GNRO-2014/00031

SUBJECT: Response to Electronic Request for Additional Information Regarding
Maximum Extended Load Line Limit Plus Amendment Request, dated
3/18/2014
Grand Gulf Nuclear Station, Unit 1
Docket No. 50-416
License No. NPF-29

Request for Additional Information - Revised Technical Specification Mark-up Pages

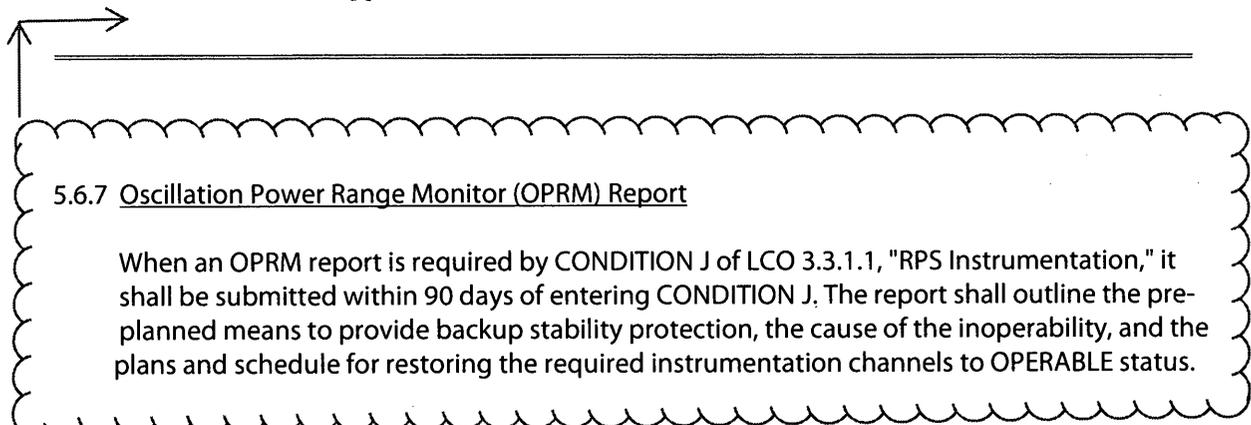
CONDITION	REQUIRED ACTION	COMPLETION TIME
I. As required by Required Action D.1 and referenced in Table 3.3.1.1-1.	I.1 Initiate action to fully insert all insertable control rods in core cells containing one or more fuel assemblies.	Immediately
J. As required by Required Action D.1 and referenced in Table 3.3.1.1-1.	J.1 Initiate alternate method to detect and suppress thermal hydraulic instability oscillations. AND J.2 ----- NOTE ----- LCO 3.0.4 is not applicable. ----- Restore required channels to OPERABLE.	12 hours 120 days
K. Required Action and associated Completion Time of Condition J not met.	K.1 Reduce THERMAL POWER to < 21% RTP.	4 hours

Replace with INSERT TS-1.

<p>J. As required by Required Action D.1 and referenced in Table 3.3.1.1-1.</p>	<p>J.1 Initiate action to implement the Manual BSP regions defined in the COLR</p> <p><u>AND</u></p> <p>J.2 Implement the Automated BSP Scram region using the modified APRM Flow Biased simulated Thermal Power - High rip function setpoints defined in the COLR.</p> <p>J.3 Initiate action to submit an OPRM report in accordance with Specification 5.6.7.</p>	<p>Immediately</p> <p>12 hours</p> <p>Immediately</p>
<p>K. Required Action and associated Completion Time of Condition J not met.</p>	<p>K.1 Initiate action to implement the Manual BSP Regions defined in the COLR.</p> <p><u>AND</u></p> <p>K.2 Reduce operation to below the BSP Boundary defined in the COLR.</p> <p><u>AND</u></p> <p>K.3 ----- NOTE ----- LCO 3.0.4 is not applicable. ----- Restore required channels to OPERABLE.</p>	<p>Immediately</p> <p>12 hours</p> <p>120 days</p>

<p>L. Required Action and associated Completion Time of Condition J not met.</p>	<p>L.1 Reduce THERMAL POWER to < 16.8% RTP.</p>	<p>4 hours</p>
